Review Committee Report

Conceptual Design

Capture Cavity 1 Modifications

May 2012

FIGURE 1.1 Capture Cavity 1 Cross Section

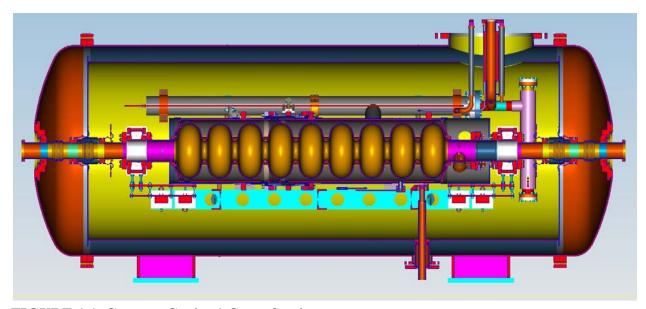
The new support frame system has many bolted or welded connections. Cumulative tolerances could be an issue for alignment of the cavity or of the needle bearing slide systems. Cryomodule performance is most effected by alignment in the pitch and yaw directions. Survey sticks will be added to the cavity end flanges in order to ensure visibility.

Rotation of the manual beam valves due to tolerances will complicate the assembly and effectiveness of the support and slide mechanism.

The number of bolted connections raises concerns about loosening due to thermal cycling or vibration. Past experience has shown that there is sufficient vibration associated with the slow tuner motor to loosen screwed connections. It is planned to Loctite bolted connections in this area. It was suggested that CM-1 could be a good source of statistics associated with the loosening of bolted connections.

The line connecting the lower portion of the liquid level can with the bottom of the cavity needs to remain horizontal to ensure that the liquid levels between the two are properly equalized.

It is planned to add MLI to the two cylindrical portions of the helium vessel, but not over the blade tuner. This will be important for ensuring that the relieving requirements are not increased for the modified CC-1.

The cavity support frame will be cooled to 5K. It will be important to quantify the heat load that can be transferred from the support frame to the 2K cavity.

It had not been fully thought out as to when and how the two beam tube extensions would be cleaned, installed, leak checked and ultimately fitted through the end caps. There is not sufficient clearance for a rotatable Conflat flange to fit through the existing hole in the end caps. As a result, it is planned to install a split ring style after it passes through the end cap.

- 1. Develop assembly sequence for the end beam tube spools considering cleaning, leak checking, bellows temporary vacuum support and final end cap installation.

- 2. Investigate cumulative tolerance effect on cavity alignment and needle bearing slide performance.
- 3. Investigate pin anchor tolerance and flexing on cavity alignment.

- 4. Investigate alternative cavity and vacuum valve slide scheme in order to minimize the number of bearing surfaces and therefore the potential for binding.

- 5. Add the port to the vacuum vessel and 80K shield to allow access to the slow tuner after understanding the implications on the 80K shield trace tube routing.

- 6. Analyze the total force on the support rods after considering the increased total weight of the cold mass, pre-stress requirements and cool down stress.

- 7. Analyze cool down stress and distortion where dissimilar metals are connected or thermal resistance exists.
- 8. Investigate the thermal effectiveness of the various clamped thermal intercept strap schemes and consider ways to minimize the reliance on small mechanical contact resistance methods.

- 9. Develop a preliminary cryomodule assembly scheme in order to ensure that access to components, such as intercept straps or cabling, is convenient.

- 10. Consider if there are practical means for reducing the number of flanged 2K joints within the cryostat.
- 11. With the removal of the 5K shield, the functionality of the 80K shield becomes more important. Carefully consider openings in the shield where 2K surfaces could see room temperature surfaces.

- 12. Add MLI to the helium vessel and two-phase pipe in order to limit the heat load during loss of cryostat vacuum accident.
- 13. Evaluate the additional heat load to 2K, both generally and locally at attachment points.
